RE: Tree Impact Assessment Report - Tree #23 MN 472 7119 80th Ave. SE Mercer Island, WA.

## 1.0 Impact Assessment

The following detail from sheet A1.1 shows the existing and proposed topography for the driveway within the drip line of tree #23.

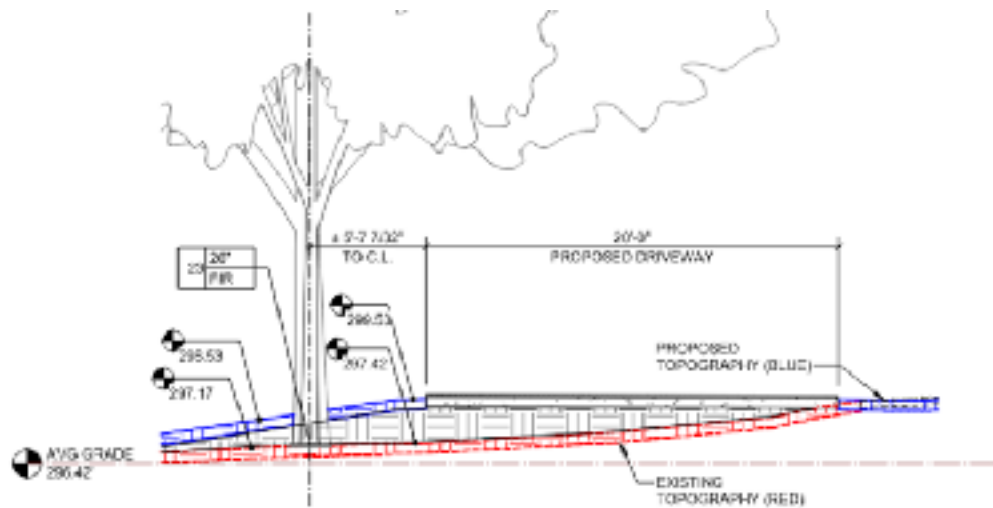
This report addresses recent comments issued by the City of Mercer Island regarding encroachment proposed within the drip line of tree #23, a right-of-way tree, requesting an advanced root analysis for the area beneath the proposed driveway. Presumably, the

referenced advanced root analysis requested by the city is air/water excavation to assess the roots in the area beneath the proposed driveway. Given the nature of the proposed encroachment, it is our opinion that the advanced root analysis is not necessary and could be detrimental to the condition of the tree as any removal of soil from around the roots will inevitably result in root damage and loss, if even just minor.

As it specifies, the red line is the existing topography, the blue line the proposed topography. Installation of the driveway will not require any ground disturbance within the drip line of the tree; it will rather require a slight amount of fill. Therefore, since no roots will be impacted, an advanced root assessment is not necessary.
